## KD8 (-B) Modular Door Station(Main Modular)

# Version: V2.2.63\_build230204 Release Note

(2023-02-10)

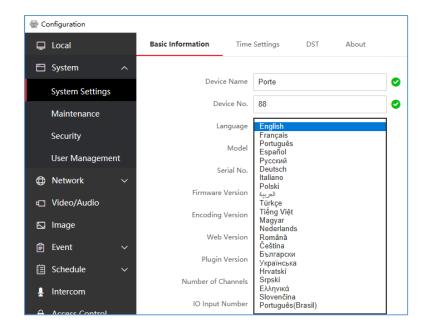
1. Add sub module backlight control: 4 modes (close, open, auto and custom), support DS-KD-KK, DS-KD-KP modules

Close: always OFF Open: always ON

**Auto**: ON and OFF according to the ambient light brightness **Custom**: ON and OFF according to configured time schedule

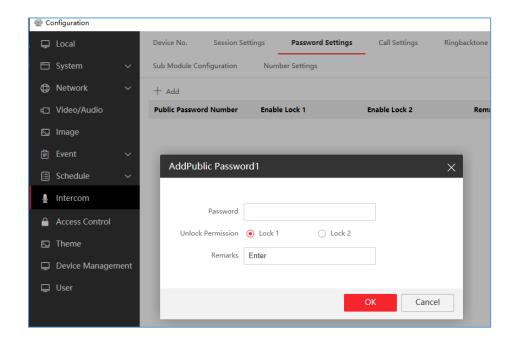
1. Support swipe card to open lock2: when adding new person, you can link to lock 1 or lock 2, and after swipe card, the related lock will be open.

Note: before the lock was linked to card module DIP switch, now we cancelled this logic so that we can open different lock with same card module.

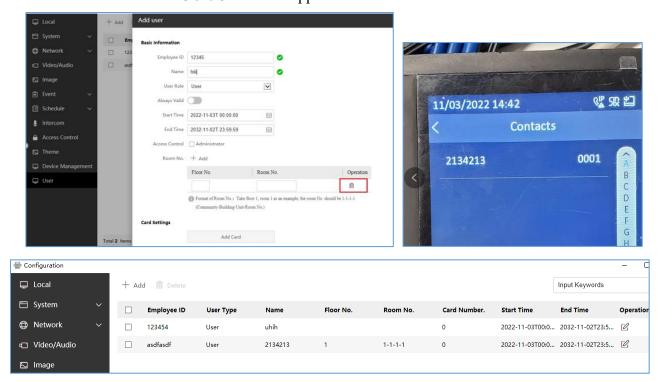
- 3. When open door2 with card or public password, but door2 is not enabled from main module KD8003, the device will prompt "Bi-Bi" sound and will not upload any event to iVMS or HikCentral (device will upload "invalid card" event in previous version firmware)
- 4. Support not showing the person in DS-KD-DIS and KD-TDM module.

When adding person, if you don't input the room No., this person will not be displayed in KD-DIS or KD-TDM module
